MAINE TURNPIKE AUTHORITY

ADDENDUM NO. 1

CONTRACT 2018.20

YORK TOLL PLAZA
MILE 8.8

SPECIAL PROVISIONSECTION 403HOT MIX ASPHALT PAVEMENT(Pavement Table)

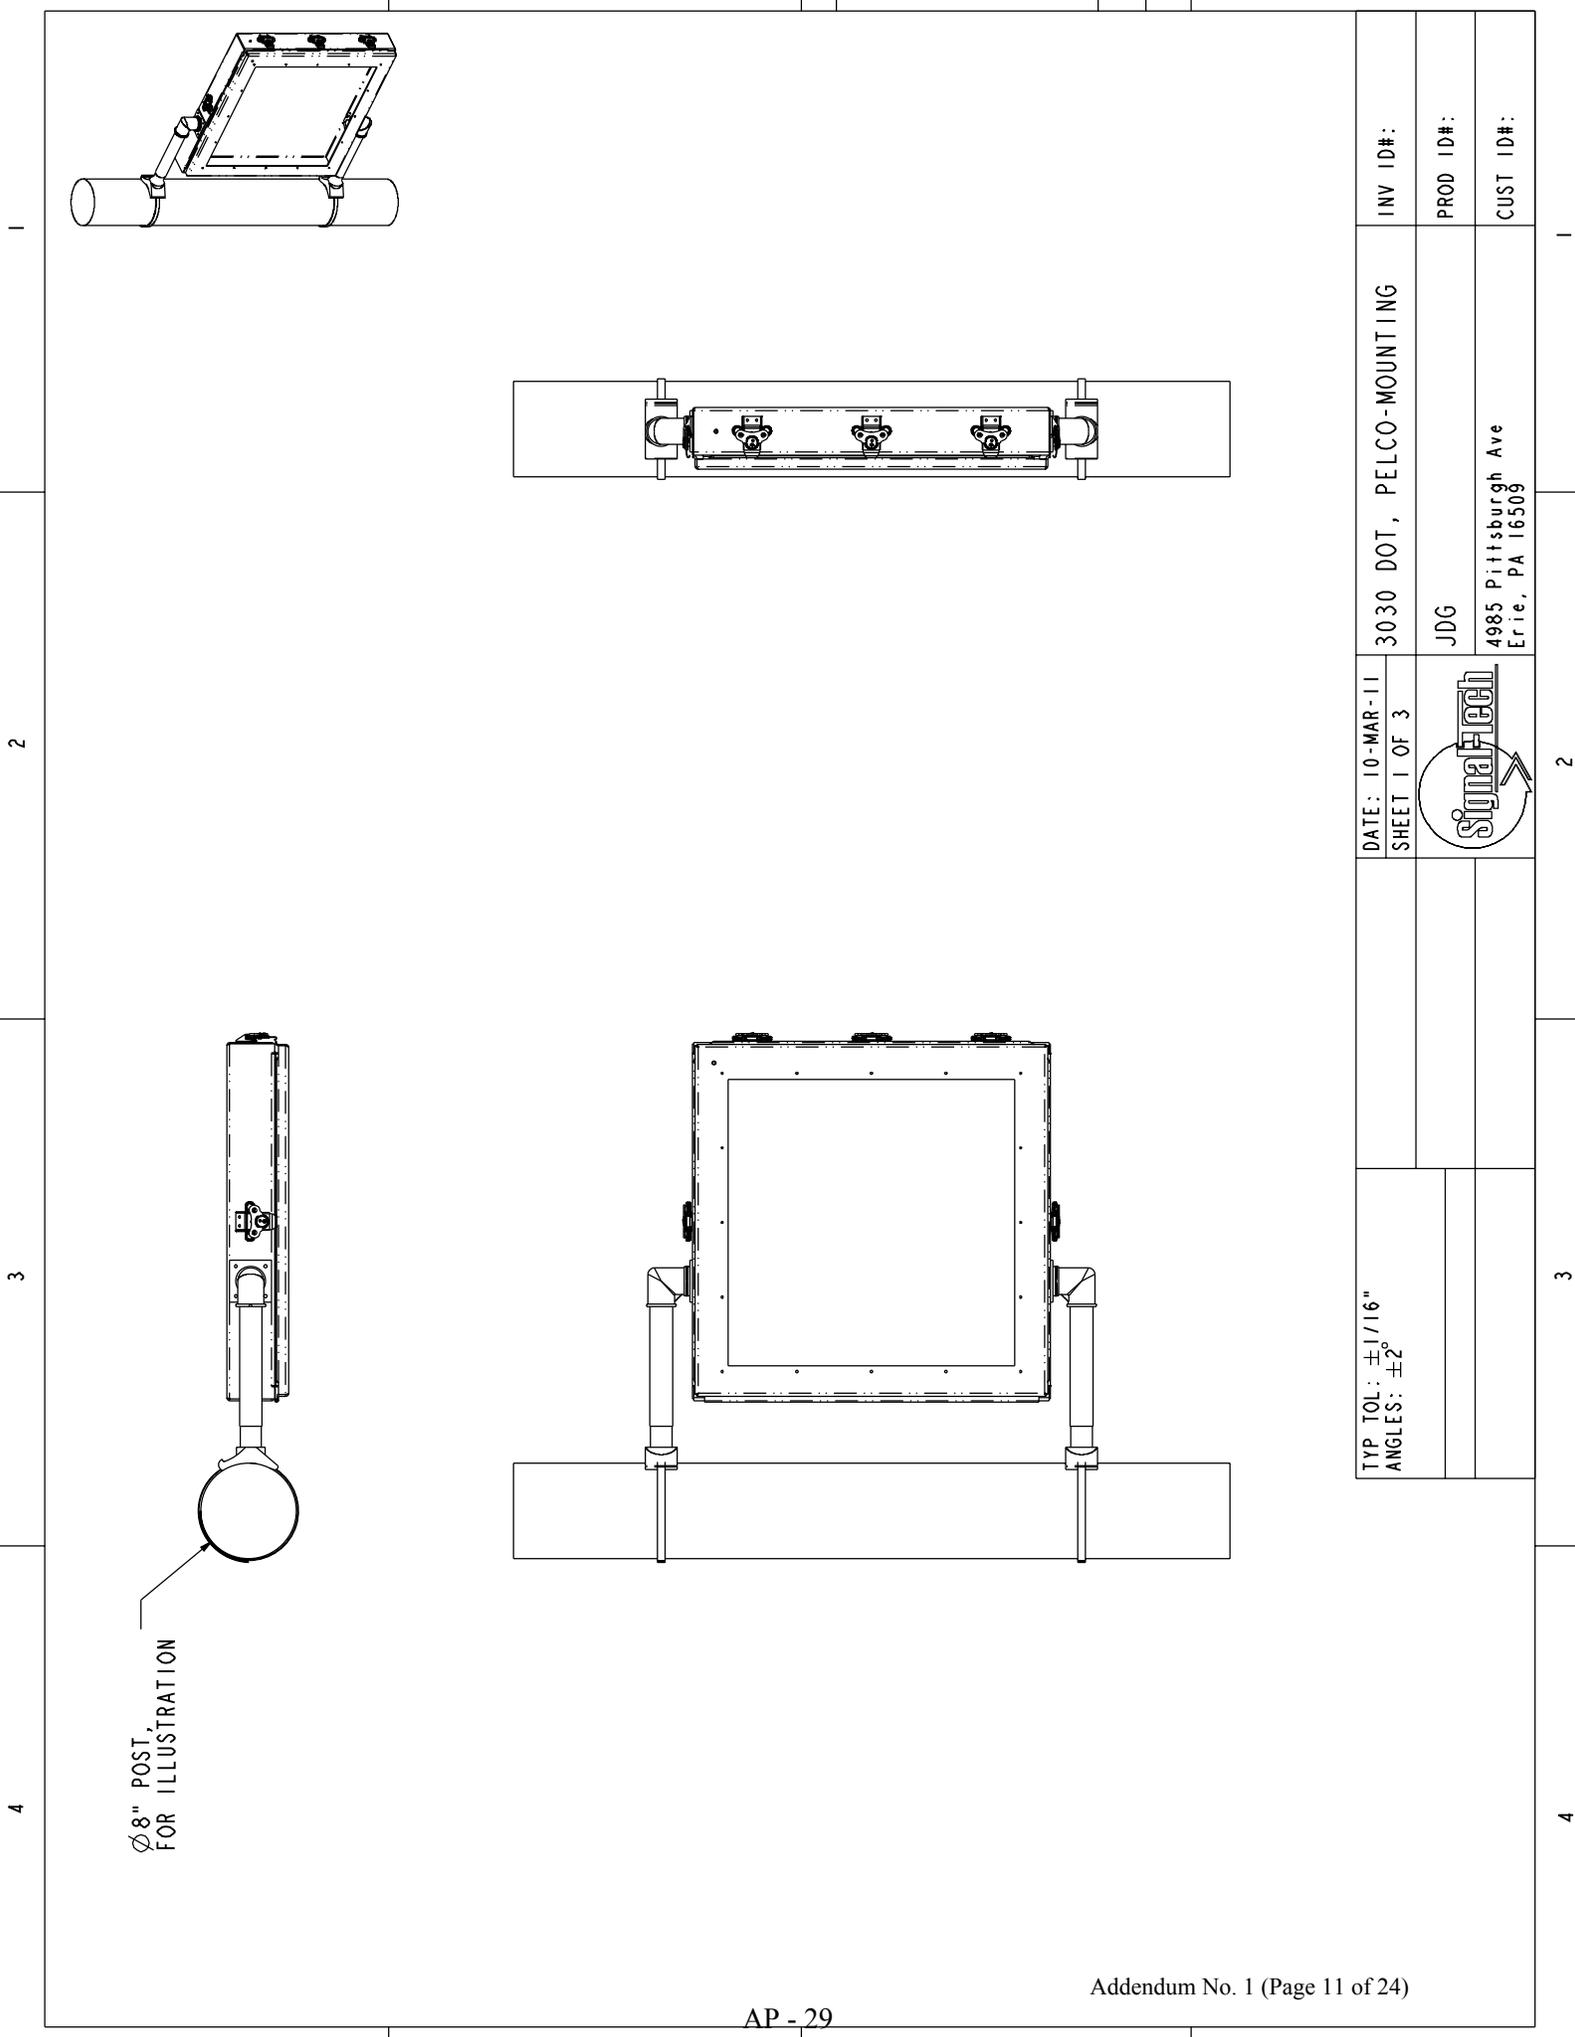
Special Provision 403 – Hot Mix Asphalt Pavement (Pavement Table) SP-51 and SP-52 deleted and replaced with SP-51 and SP-52.

20. Surface pavement. Will an anti-strip additive be allowed instead of the lime additive?

Answer: No. Special Provision 403 – Hot Mix Asphalt Pavement (Pavement Table) has been revised to require both an anti-strip additive and lime.

3030 DOT, PELCO-MOUNTING

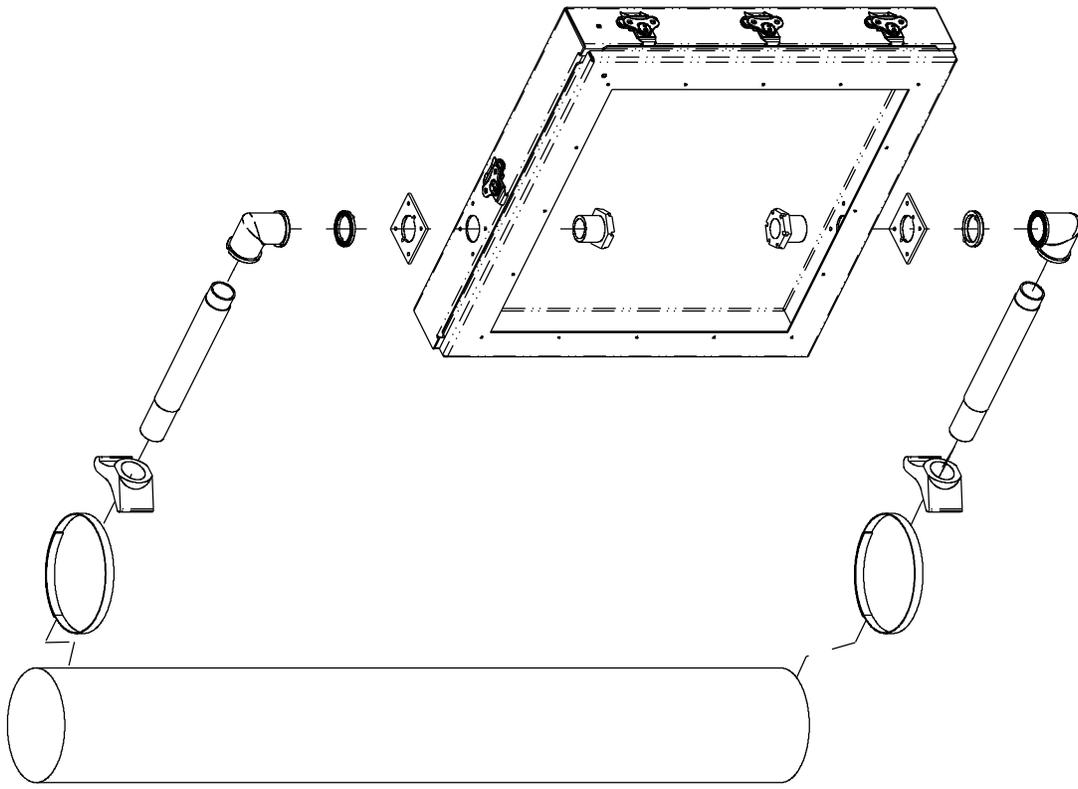
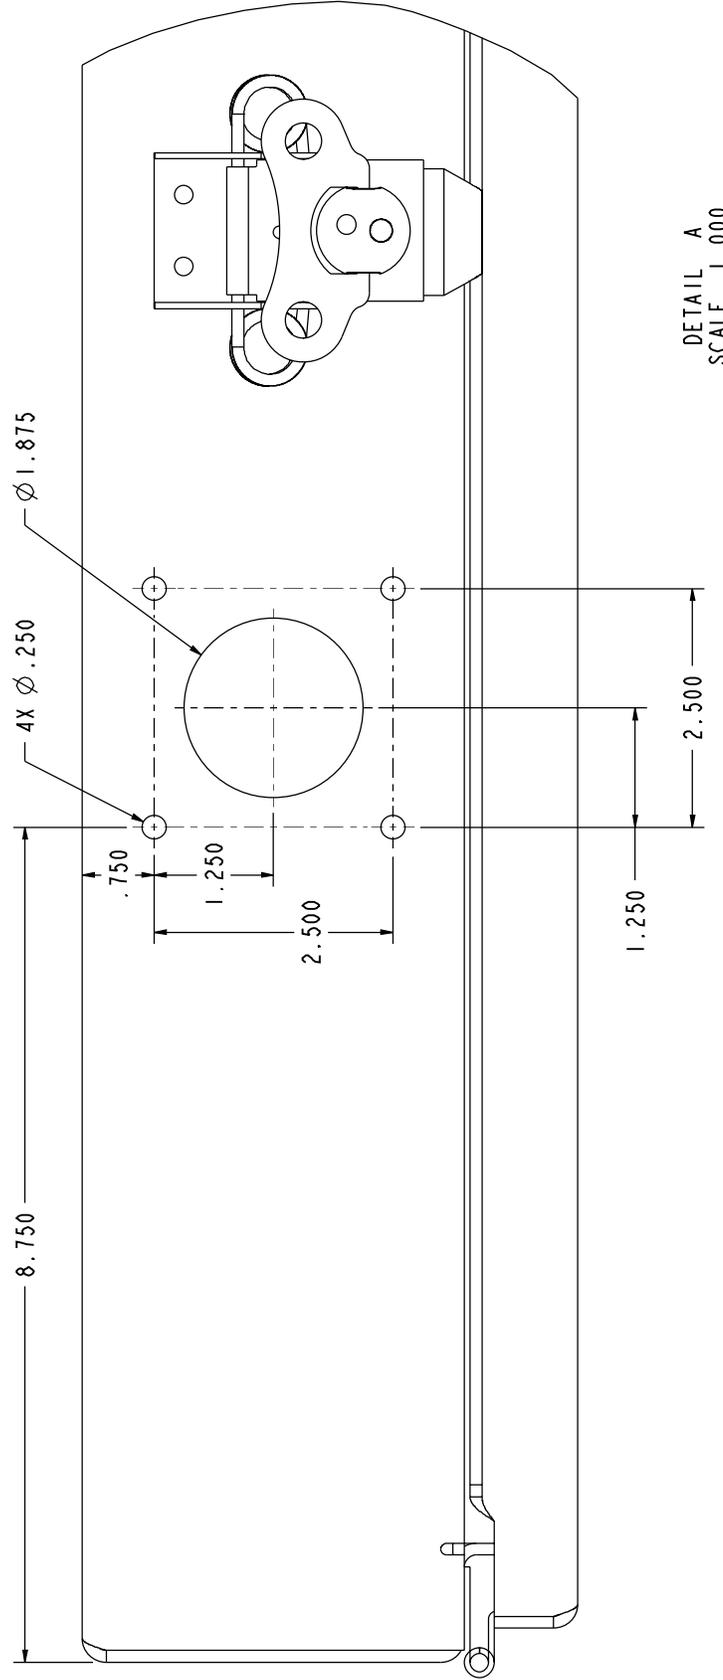
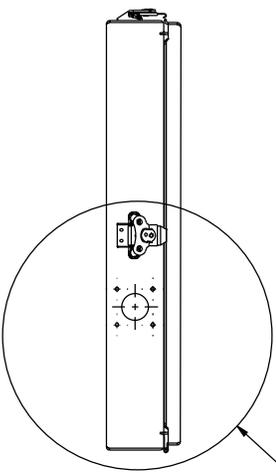
Specifications, Part IV - Appendix E, Product Data Sheets AP-29 to AP-30 deleted and replaced with AP-29 to AP-30.
